Proposed Plan Change 7 to the Canterbury Land and Water Regional Plan

Responses to Questions of Hearing Commissioners on Council Reply Report

24 February 2021

Nitrogen floor vs N-loss relationship with a set 15% loss reduction for dairy per 10-year stage

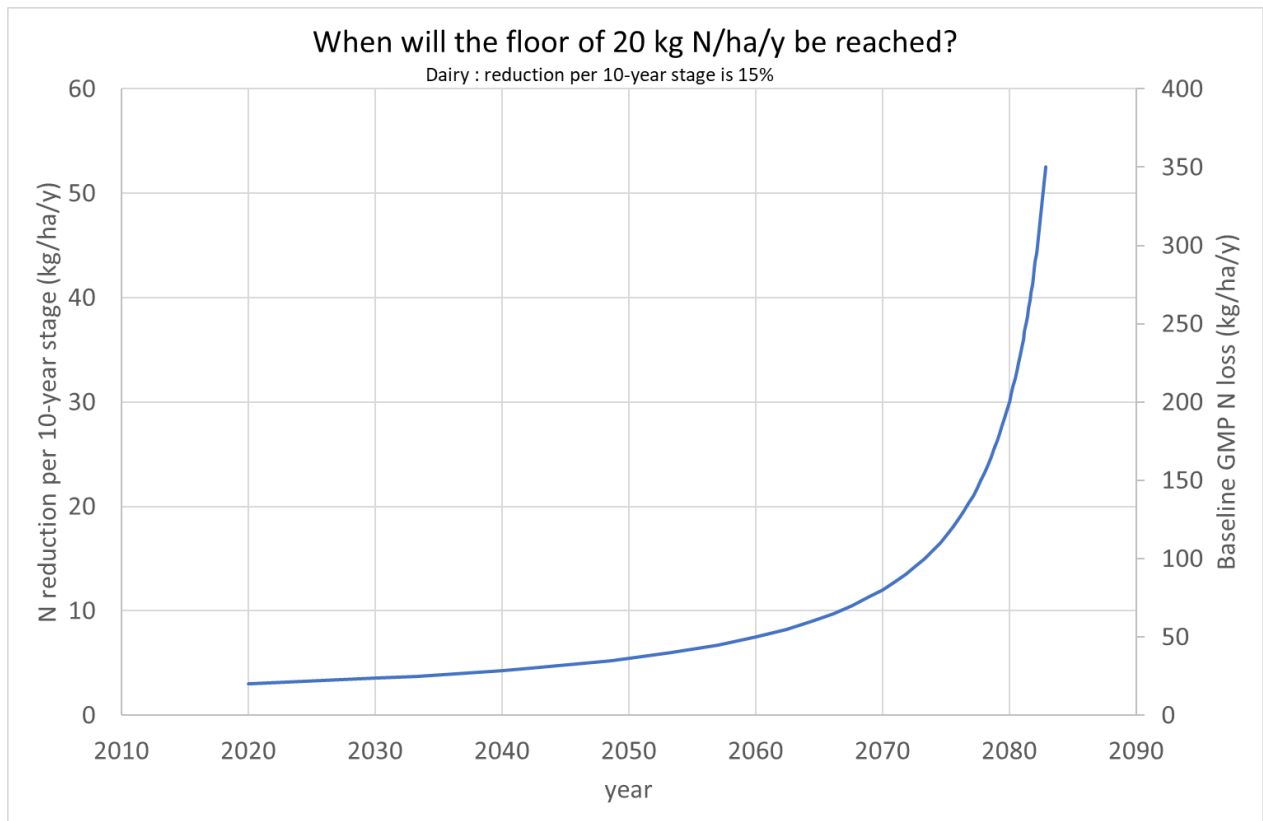
As described in the Reply Report, the relationship between the reductions per stage and the time it takes to reach a 20kg N/ha/year floor is not linear. This memorandum describes that relationship and identifies the reduction in nitrogen loss below which the percentage reductions are not required to meet a floor of 20kg N/ha/year.

The relationship between Baseline GMP/N-loss reduction and time when the N-loss floor is reached is not linear, see graph below.
